PIC32MZ Graphics (DA) Family Silicon Errata and Data Sheet Clarification

The PIC32MZ Graphics (DA) family devices that you have received conform functionally to the current Device Data Sheet (DS60001361H), except for the anomalies described in this document.

FIGURE 1: Posc CRYSTAL CIRCUIT

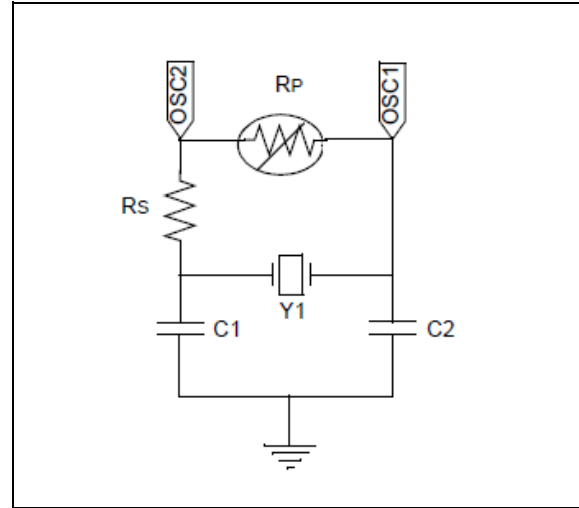
The POSC has been tested in a normal power-up sequence and supports specific crystal operation.

The Primary Oscillator (POsc) has been characterized to operate at 8 MHz and 12 MHz when the circuit shown in Figure 1 is implemented, and the operating conditions listed in Table 3 are met.

Crystal Frequency (See Note 1)	Series Resistor Rs	Posc Gain Setting POSCGAIN<1:0> (DEVCFG0<20:19>)	Posc Boost Setting POSCBOOST (DEVCFG0<21>)
8 MHz	2 kΩ	'0b00 (GAIN_0)	'0b1
12 MHz	1 kΩ	'0b00 (GAIN_0)	'0b1

Note 1: Using any other crystal frequency will require special component selection and characterization.

2: A parallel register (RP) should not be used to increase the gain of the Posc.

FIGURE 2: EXTERNAL RESET CIRCUIT

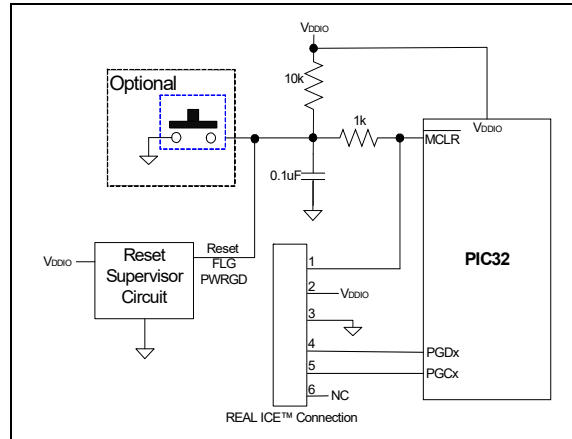
A system Reset is not generated on a BOR event ($V_{PORIO} < V_{DDIO} < V_{BORIO}$). This will stop system clocks with all the I/O pin functions frozen in the present state until either V_{DDIO} falls to V_{PORIO} or $V_{DDIO} > V_{BORIO}$.

Reset device using a \overline{MCLR} pin through an external reset supervisor/monitor is shown in Figure 2. Set the SMCLR (DEVCFG2<15>) configuration bit to '0', which makes the \overline{MCLR} to act as a POR Reset instead of a normal system reset.

- Minimum Reset trip voltage of the external supervisor should be $V_{BORIO} (Max)+0.5V$.
- The external reset supervisor/LDO output going to \overline{MCLR} should have an open drain output to not interfere with the MPLAB programming/debug tools.

When this work around is implemented, the minimum V_{DDIO} operating voltage of the application needs to be above the reset supervisor maximum trip voltage + 0.2V, where 0.2V compensates for variation in the external reset supervisor voltage.
